MEMORANDUM

SUBJECT: Liberty Industrial Finishing, Ecological Evaluation Revised Scope of Work, March 9, 1998

Re: Ecological Evaluation
Revised Scope of Work and Responses to Comments
Continued Remedial Investigation/Feasibility Study (RI/FS)
Liberty Industrial Finishing Site
Farmingdale, New York

TITLE
 ECOLOGICAL EVALUATION
 REVISED SCOPE OF WORK
 LIBERTY INDUSTRIAL FINISHING SITE
 FARMINGDALE, NEW YORK

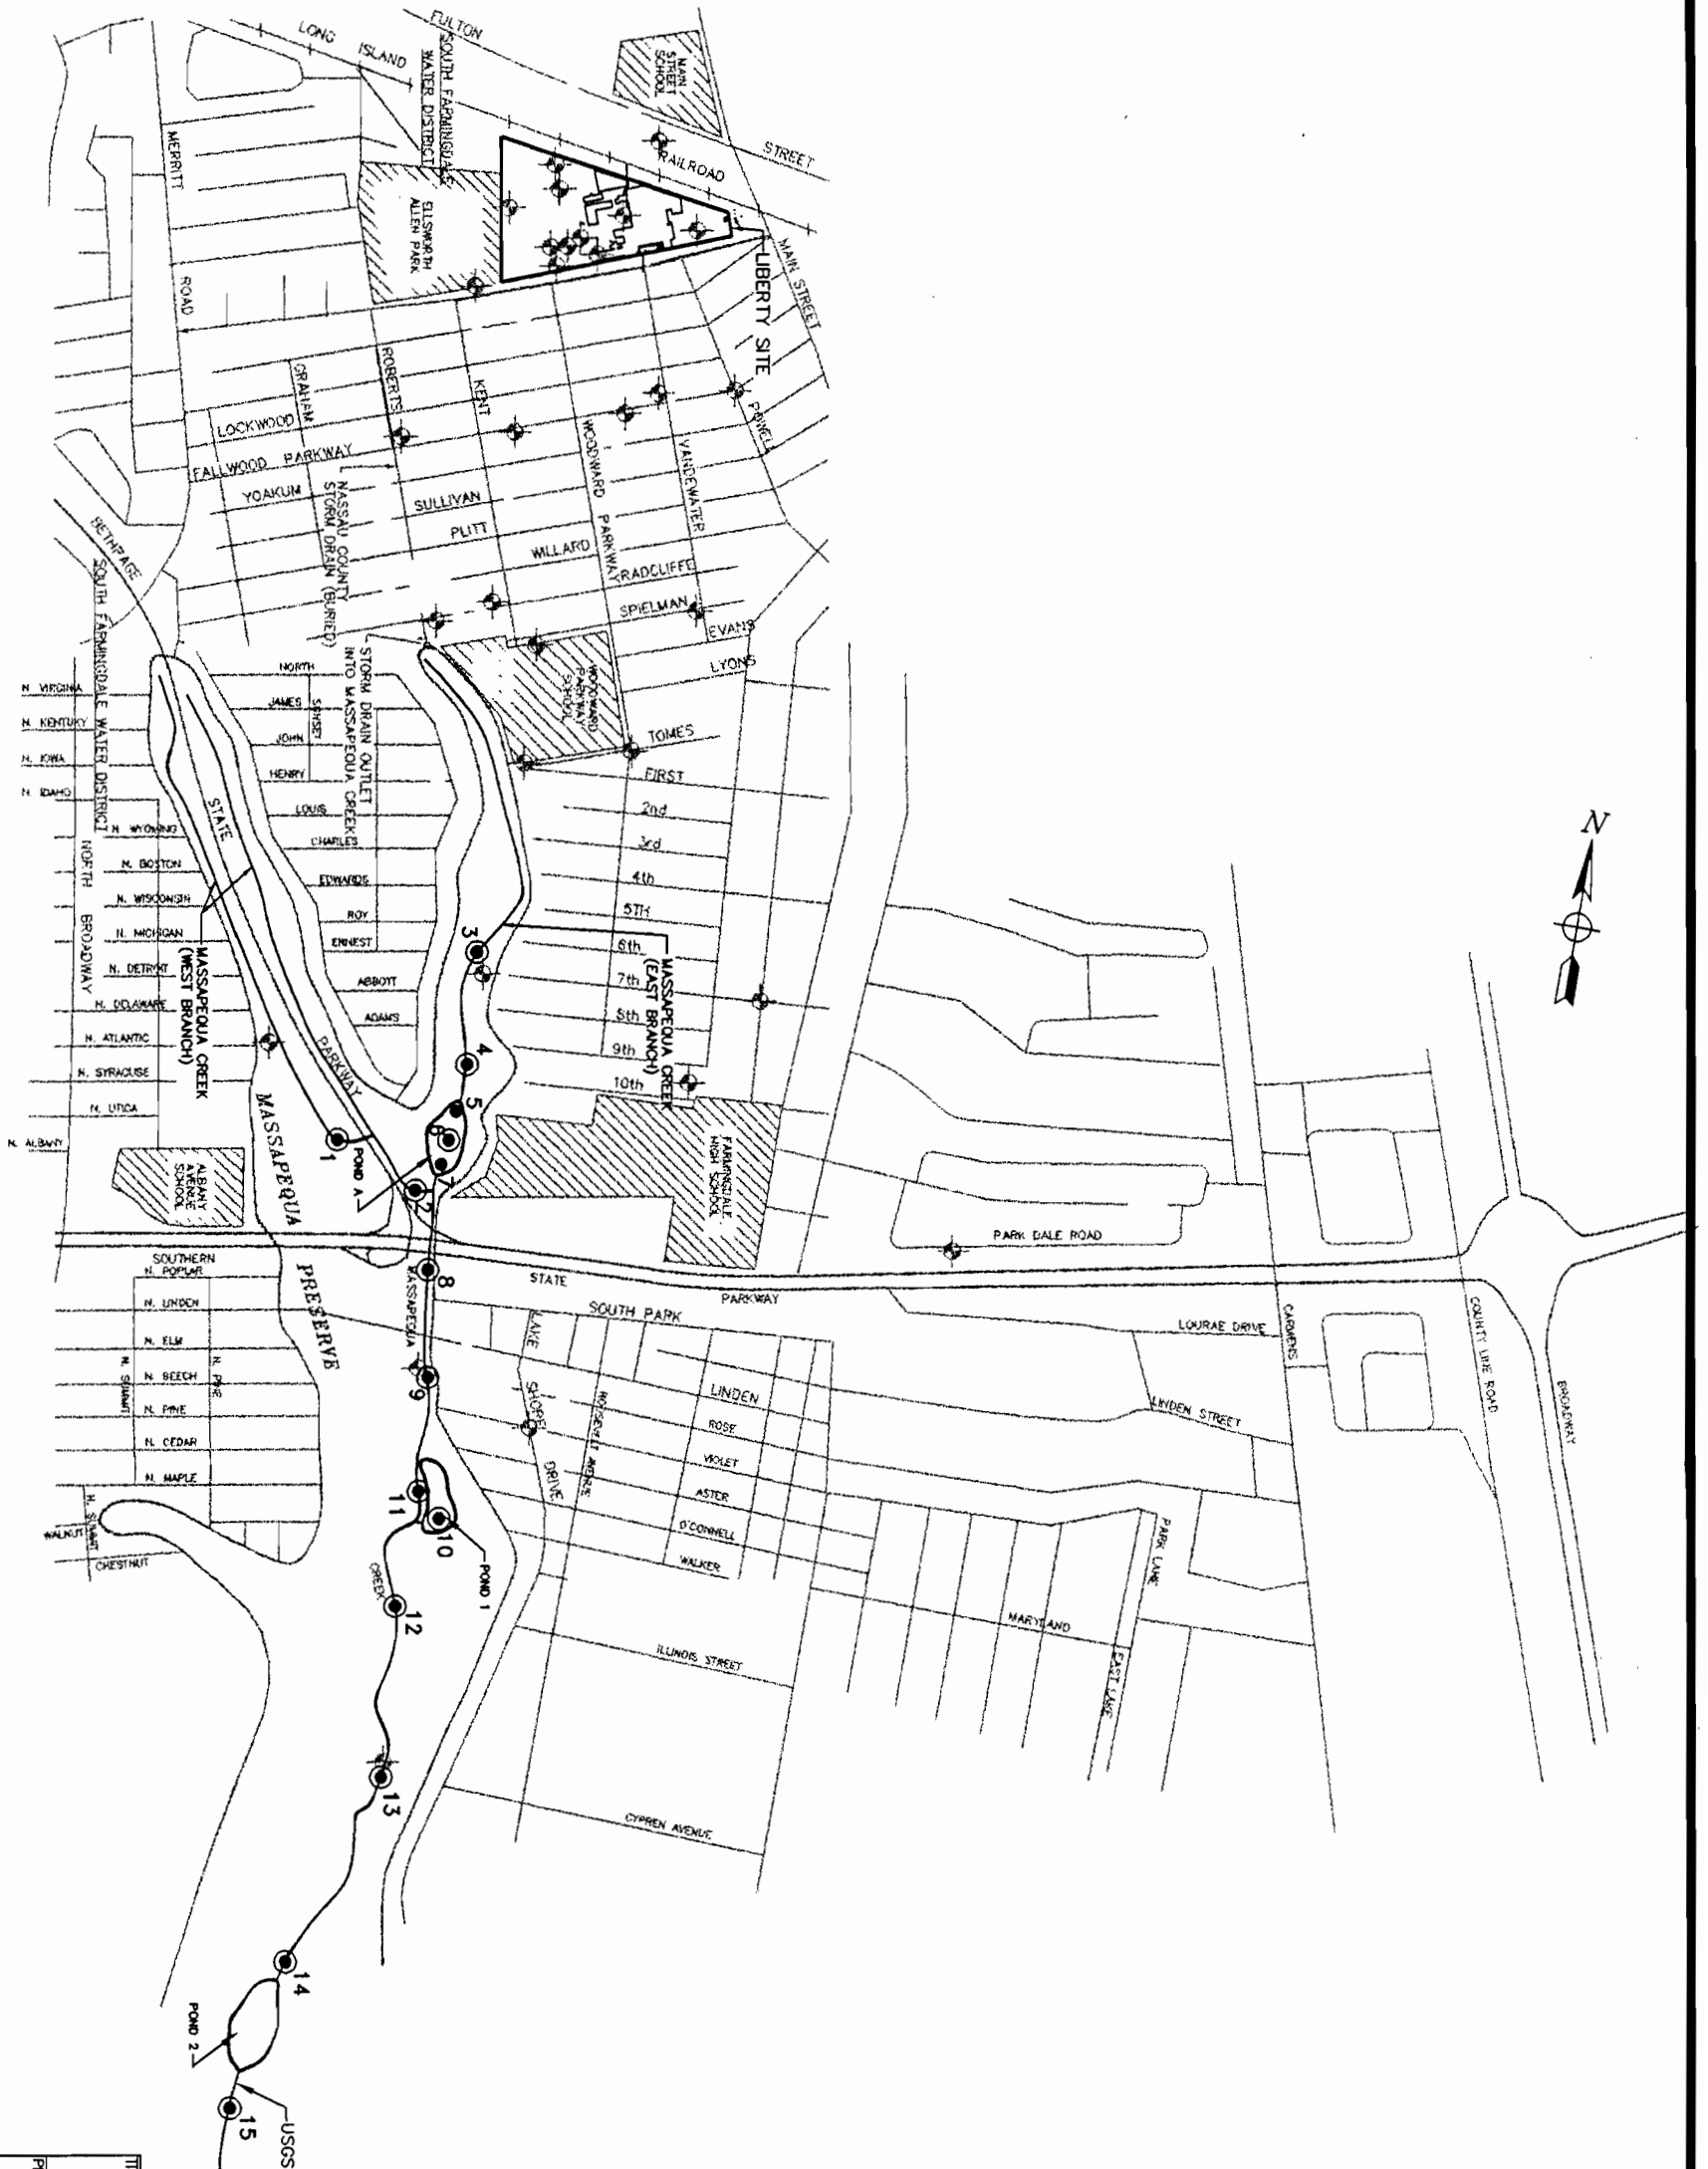
3. In Figure 1, there are fourteen proposed sampling locations. However, it is noted in the SOW that three sediment samples will be collected in each of the two ponds. In addition, there are proposed surface water sampling locations illustrated in this figure which are not included in the text of the SOW. These discrepancies should be clarified. It may also be appropriate to differentiate the reference locations in the figure.

4. *With regard to the map dated 4-28-97, it is recommended that the samples proposed under the SOW be clearly differentiated from stations proposed in the 1995 EPA work plan. The figure depicting groundwater, surface water and sediment sampling locations is difficult to interpret. A separate map showing only the stations proposed in the SOW would be helpful. In addition, the use of different symbols or codes for the reference stations is suggested.*

Response: The revised scope of work now proposes fifteen sampling locations, based on the January 1998 stream survey. Please refer to Figure 1 in the revised work plan for specific sampling locations. Per the 1995 SAP, sediment/surface water samples are to be analyzed as follows:

Response: A sampling location map specific to the proposed scope of work has been prepared and is included as Figure 1 in this submittal. Sampling locations 3, 4, 6, 8, 9, 10, 12, 13, and 14 are roughly equivalent to the stations proposed in the 1995 EPA work plan. Sampling locations 1, 2, 5, 7, 11, and 15 are specific to this revised scope of work.
